CONSTRUCTION SUMMARY
Red Oaks on Bayview - Trinimont Developments Inc.

LOT / PHASE 150 / 1	REG. PLAN # 65M-4737	HOUSE TYPE Birch 2 Elev A		
------------------------	-------------------------	------------------------------	--	--

BIRCH 2 - EL: A

BASEMENT PLAN EL. A

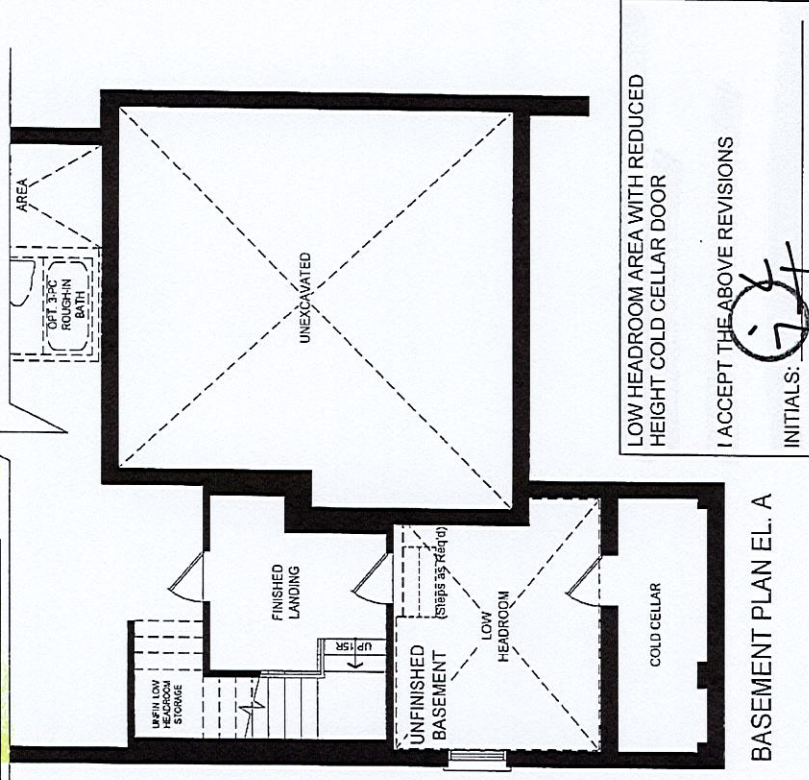
LOW HEADROOM AREA WITH REDUCED HEIGHT COLD CELLAR DOOR

GROUND FLOOR PLAN. A

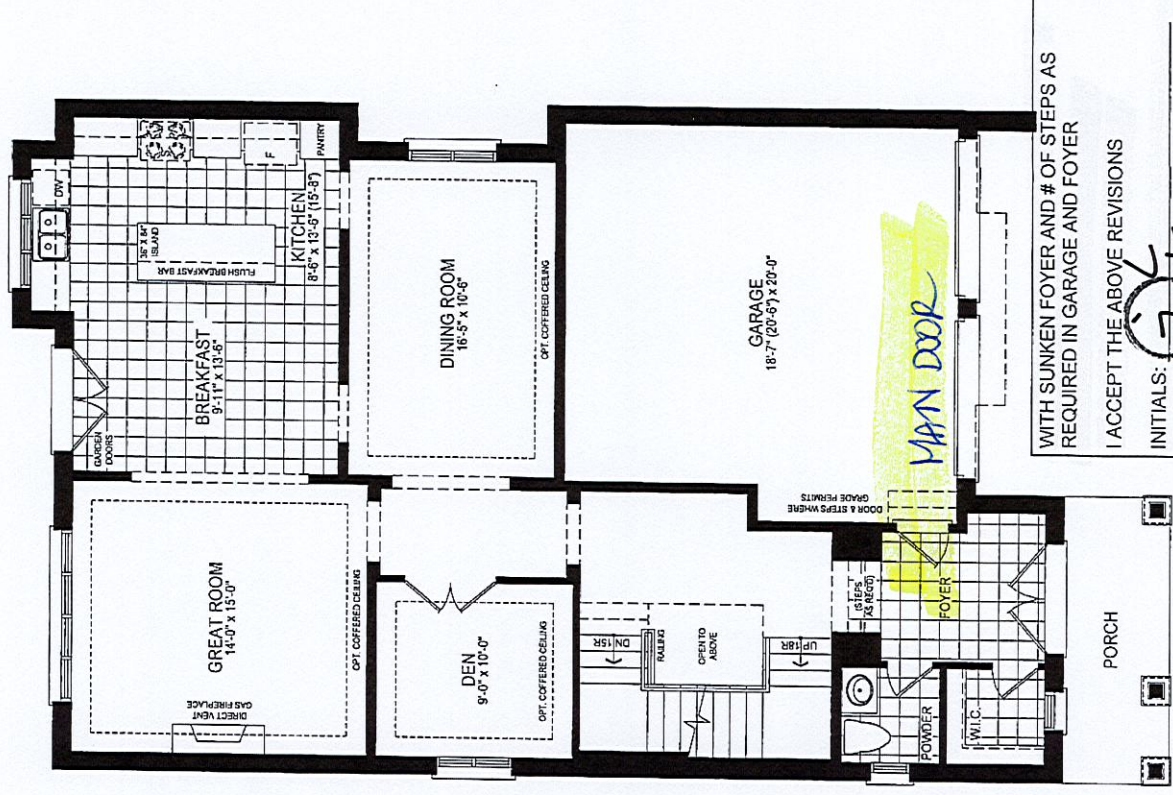
WITH SUNKEN FOYER AND # OF STEPS AS
REQUIRED IN GARAGE AND FOYER

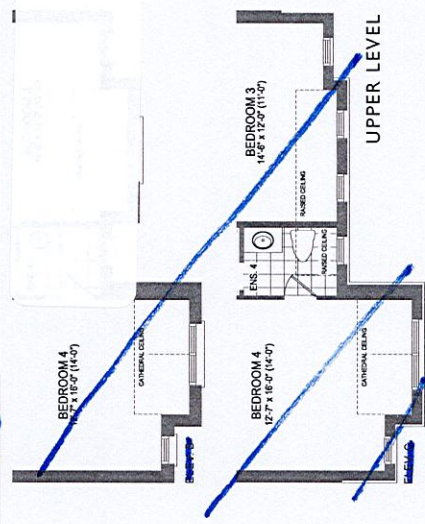
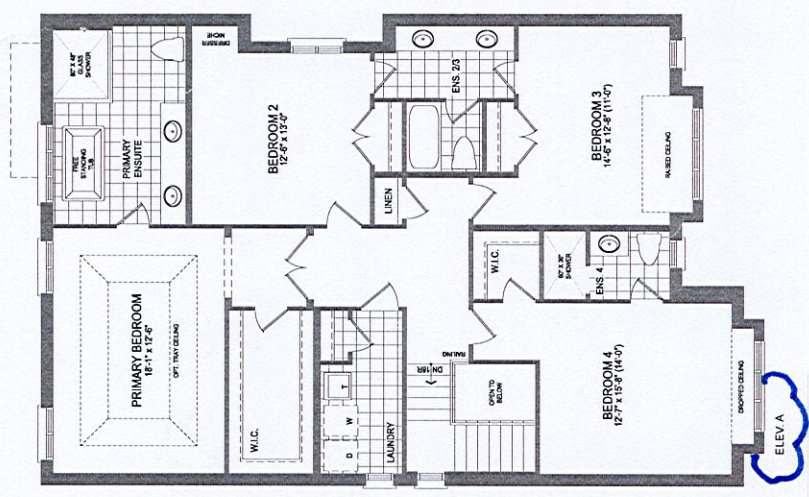
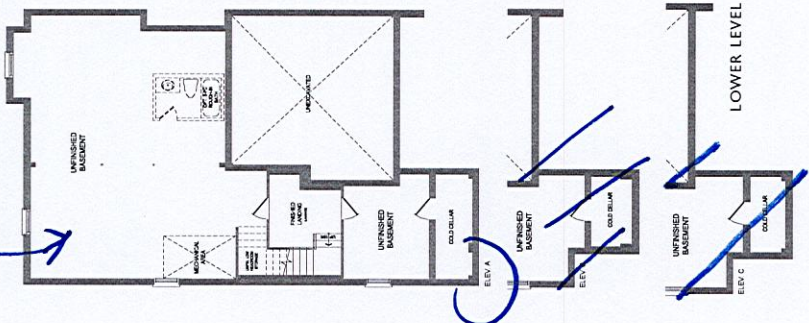
★ REVISED FLOORPLAN
SUNKEN FOYER TO ACCOMMODATE
GARAGE MAN DOOR

9 FT BASEMENT CEILING
HEIGHT.
